CITY OF CONWAY, ARKANSAS HISTORIC DISTRICT COMMISSION

HISTORIC DISTRICT COMMISSION

October 27, 2025

- A. 1837 Robinson Ave (HDR-0925-0114) Garage Remodel
- B. 1814 Robinson Ave (HDR-1025-0120) Brick Staining

Western Elevation

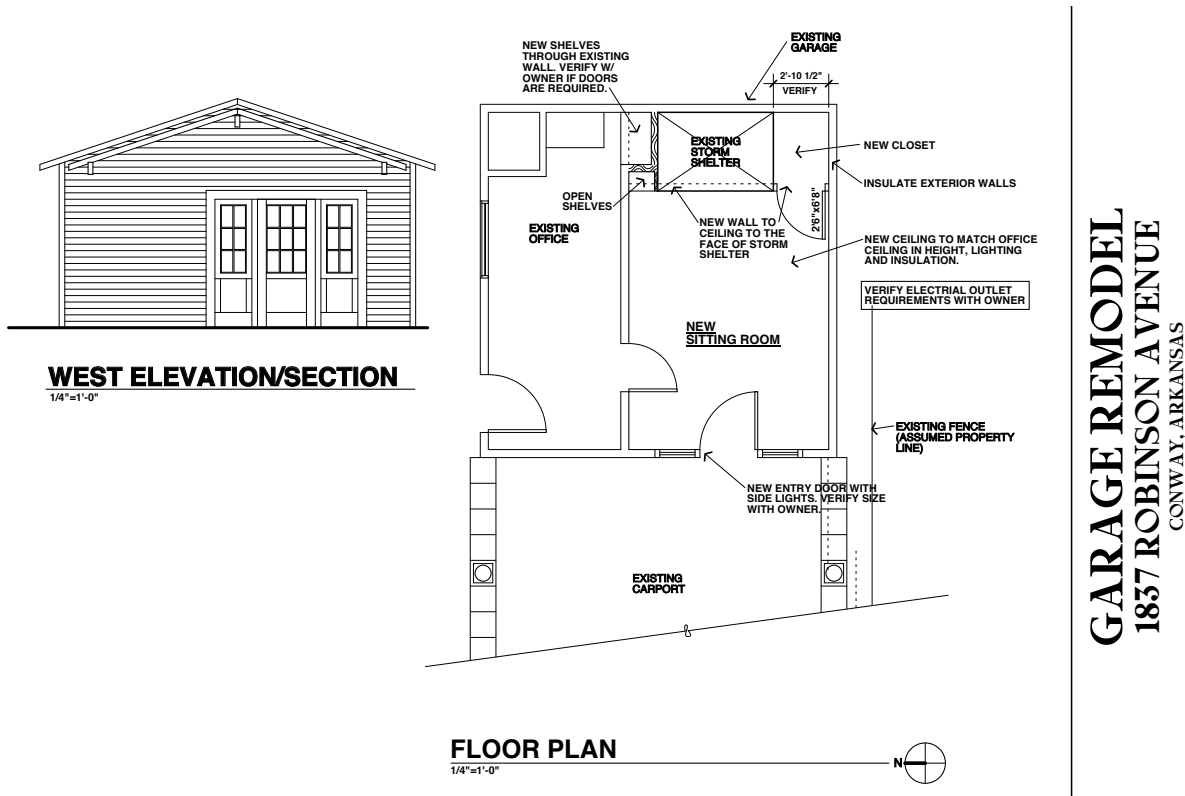
The existing, deteriorating garage door to be replaced does not contribute to the façade articulation and is obscured by the carport. The addition of doors and windows will enhance the character of the façade. The southern façade upon which dormer windows will be added is not a character-defining façade and is obscured by vegetation. The proposed materials consist of a fiberglass door and white vinyl windows with tempered glass on the western elevation and white vinyl panel slider windows with tempered glass on the southern elevation.

1. Applicant must obtain all applicable building permits* if/when a Certificate of Appropriateness is granted.

2. Lighting shall be inward, downward, and shrouded to stay within the bounds of the property.

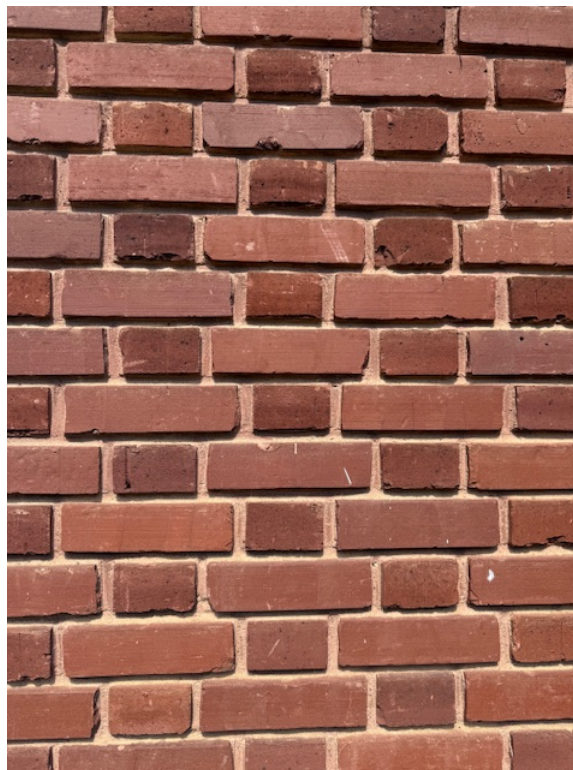
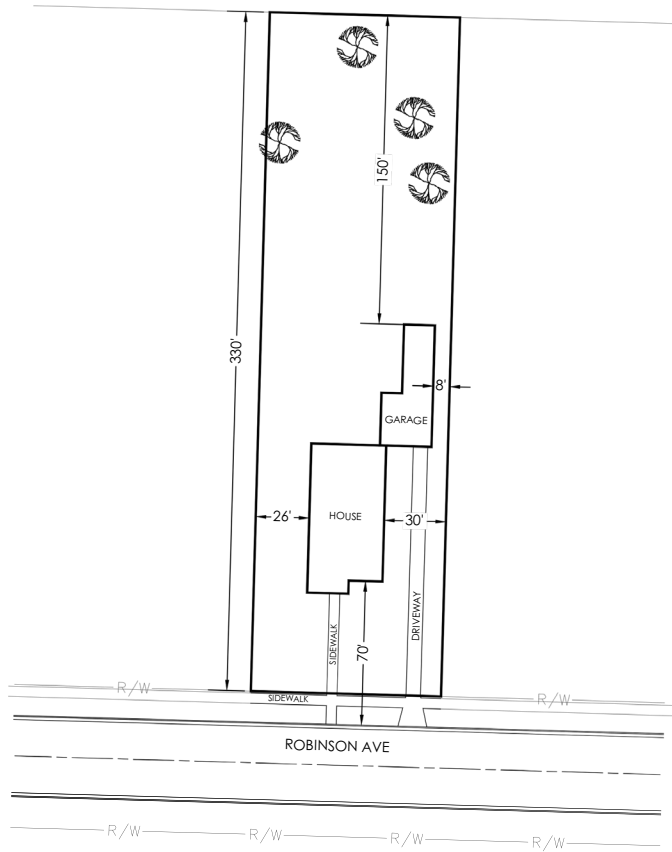
The 2020 survey did not indicate any threats to the property and no evidence of brick and mortar deterioration was provided necessitating the need for brick staining.

Water-repellent coating may be appropriate if the brick has become so porous that a coating is needed to protect it from further deterioration.

Brick Staining is a chemical treatment that should be used only when other means of maintenance have been exhausted, or there is evidence of severe deterioration.

1. Brick staining shall not be utilized until other brick maintenance options have been exhausted.
2. Masonry shall be cleaned where necessary with the gentlest means possible.

3. Damaged or deteriorated masonry shall be repaired using recognized preservation methods for piecing, consolidating, or patching.
4. Repoint masonry joints if the mortar is cracked, crumbling or missing or if damp walls or damaged plaster indicate moisture penetration.
